IFB 008-2026

F.B. Leon Guerrero Middle School's Local Area Network (LAN) and Wireless Local Area Network (WLAN) Inside Wiring Infrastructure Restoration and Upgrade

AMENDMENT 2

June 19, 2026

CAFETERIA'S LAN/WLAN SCOPE OF WORK

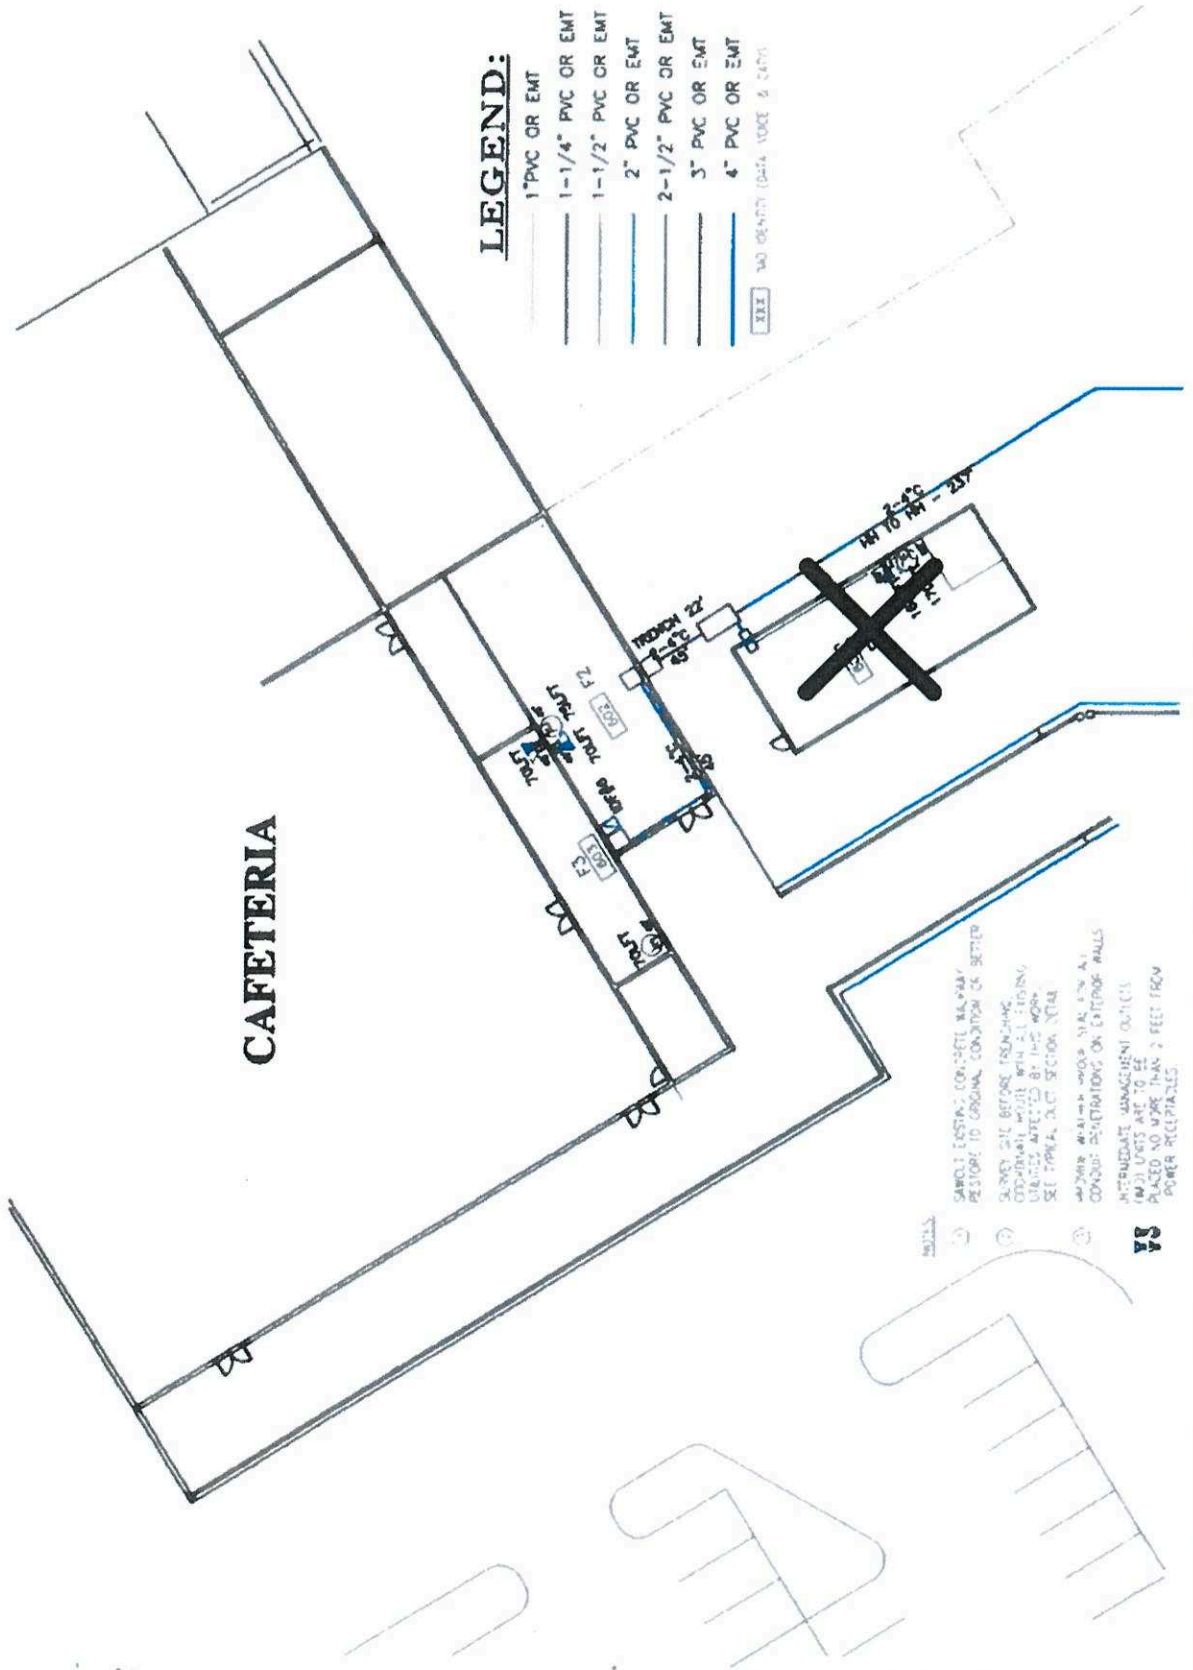
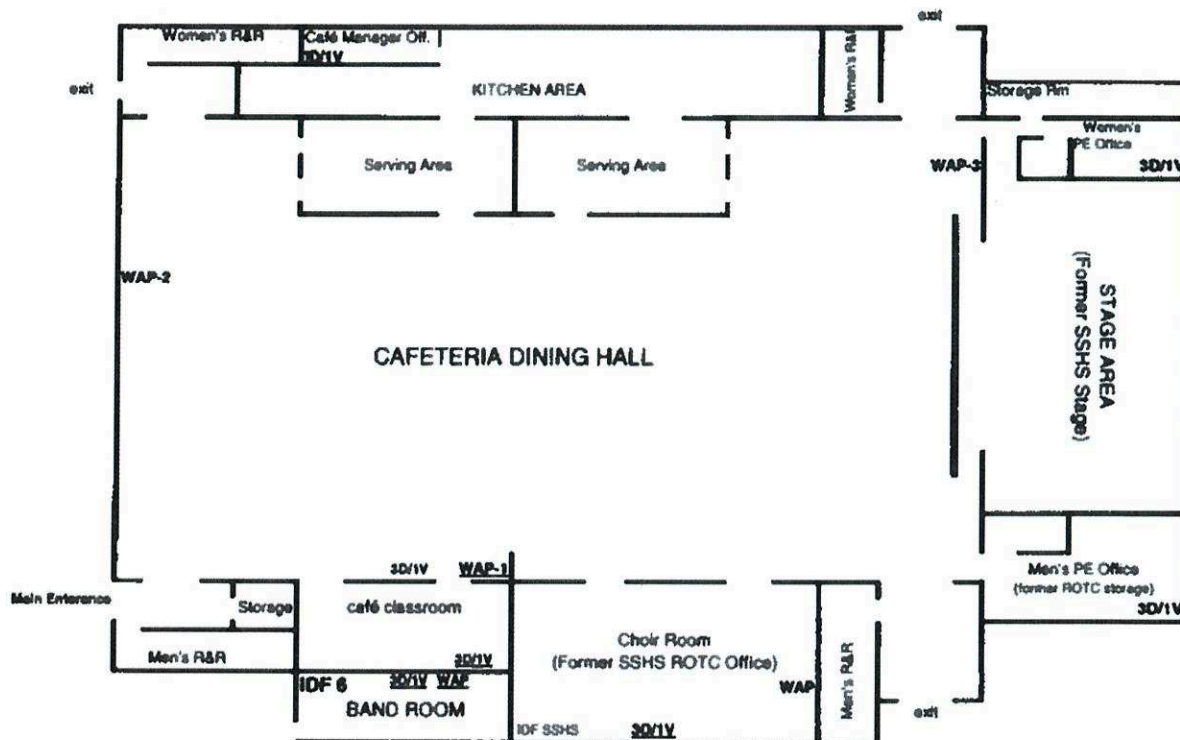
- 1 Re-route LAN infrastructure from old SSHS LAN to FBLG MS LAN
- 2 Add IMO with 3 data and 1 voice to the location listed below:
 - a) Dining Hall - In Dining Hall wall directly outside the café classroom

- b) Choir Room - at the former SSHS ROTC may use the existing IMO
 - c) Men's and Women's PE Office - Former SSHS rooms located at each side of the stage.

- 3 Add IMO with 1 data and 1 voice in the Café Manager Office.
- 4 Add WLAN infrastructure for 2 AP in Dining Hall at the location listed below:
 - a) One (1) AP install and mounted at the left-center wall from the café main entrance.

- b) One (1) AP install and mounted at the far-right wall from the café main entrance.
- 6 Add WLAN infrastructure for 1 AP in the Choir Room.
- 7 Homerun data and voice cables directly to IDF 6 in the Band Room.

- 8 Disconnect and remove SSHS LAN cabling system and old network equipment from SSHS IDF.
- 9 Remove and dispose the old SSHS IDF from the site.
